# Engineering Bulletin

Re: Service Body Strobe and Amber Lights Upgrade

Models Affected: All STAHL Service Bodies

Figure 1:

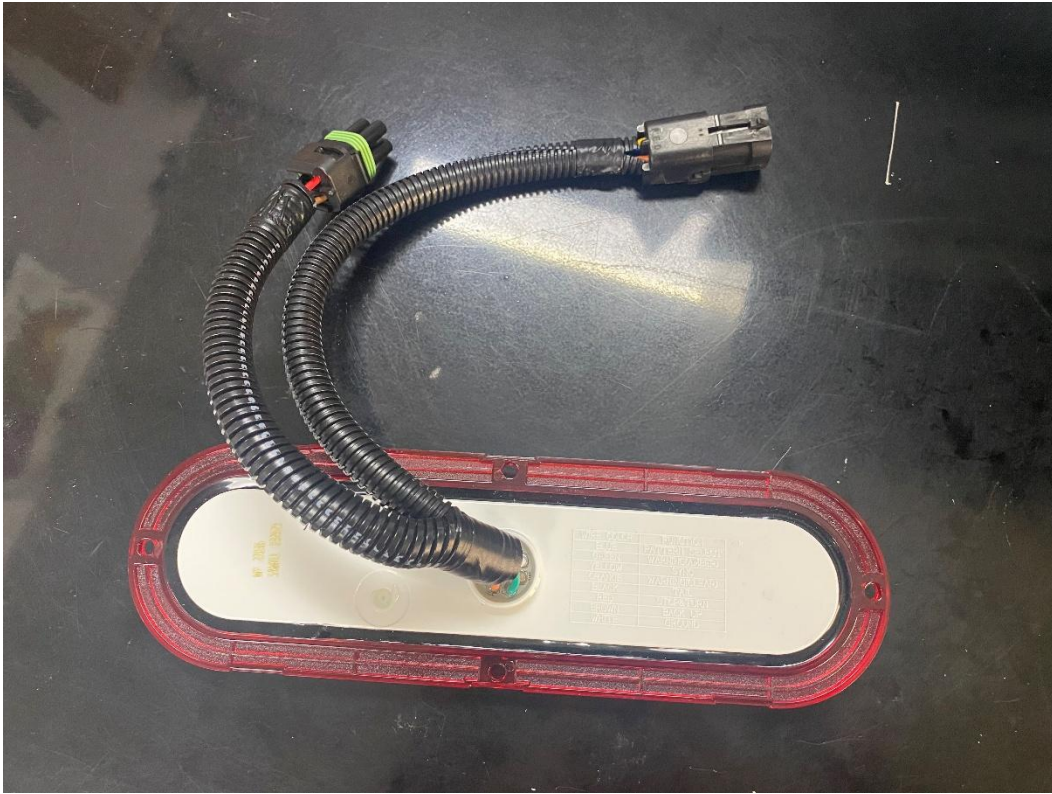
Strobe and amber light function. STAHL rear body lights will now contain strobe and amber light capabilities. This feature was introduced at Work Truck Week 2025 and is now being implemented to all STAHL service bodies. [Figure 1](#) found below shows the two harness ends that the new body lights have. The shorter male end will connect to the main body light harness as usual and provide you your stop/turn/taillights. The longer female plug will plug into the new add-on light kit 247968 that allows you to activate the integrated taillight strobe/amber function. If the strobe/amber function is not being used the extra harness from the lights can just be tied against the stop/turn/tail harness. [Figure 2](#) and [Figure 3](#) show the wiring diagram and installation instructions for the add-on kit 247968.
